Access Compliance Report

Public Rights-of-Way

Intersection ID: N/A	Main Street: E MARTIN LUTHER KING JR BV	Cross Street: S CALDWELL ST	Location: NW
ADA ID: 5A0911BBF53C	Ramp Type: Perp	Initial Pass/Fail: Pass	Overall Compliance: No
Severity Score: 5.25			
Codes/Mitigation Info/Possible Solution		Field Measurements/Component Compliance

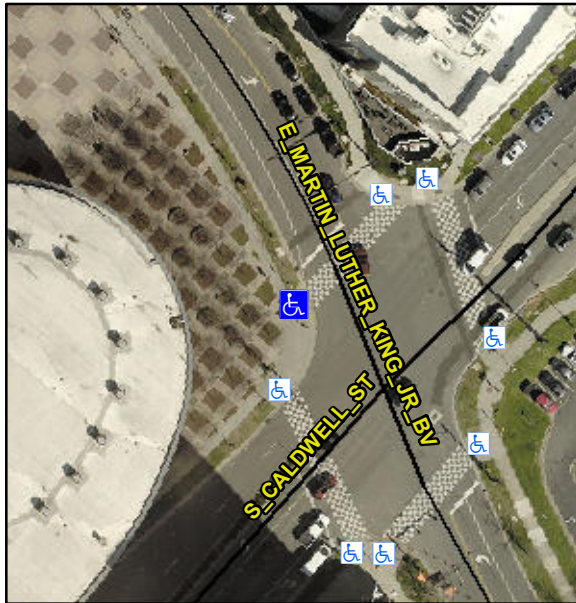
**Not Found, R304.5.3, R305.2,
R304.5.4**

Compliance	Description	Data	Compliance	Description	Data
N/A	Ramp Length (in)	83.0	Yes	Ramp Slope (%)	5.2
Yes	Ramp Width (in)	48.0	No	Ramp XSlope (%)	2.6
N/A	Flare Type LT	Sloped	N/A	Flare Type RT	N/A
N/A	Flare Slope LT (%)	5.0	N/A	Flare Slope RT (%)	8.4
N/A	Flare Traversable LT?	Yes	N/A	Flare Traversable RT?	No
Yes	Landing Length (in)	60.0	Yes	DWS Provided?	Yes
Yes	Landing Width (in)	60.0	Yes	DWS Contrast?	Yes
Yes	Landing Slope (%)	1.8	Yes	DWS Length (in)	24.5
Yes	Landing X Slope (%)	1.6	Yes	DWS Full Width?	Yes
N/A	Landing Curb? (Y/N)	No	No	DWS Offset (in)	4.5
N/A	Shared Landing?	No			
Yes	Gutter Ponding?	No	No	Gutter Slope (%)	6.9
Yes	Gutter Lip Ht (in)	0.0	No	Gutter X Slope (%)	3.6
N/A	Painted X Walk1?	Yes	N/A	Painted X Walk2?	N/A
	X Walk 1 Direction	To NE		X Walk 2 Direction	N/A
N/A	X Walk 1 Width (in)	144.0	N/A	X Walk 2 Width (in)	N/A
	X Walk 1 Slope (%)	2.7		X Walk 2 Slope (%)	N/A
	X Walk 1 X Slope (%)	1.4		X Walk 2 X Slope (%)	N/A

**Remove & Replace Entire Ramp.
Remove & Replace Gutter.**
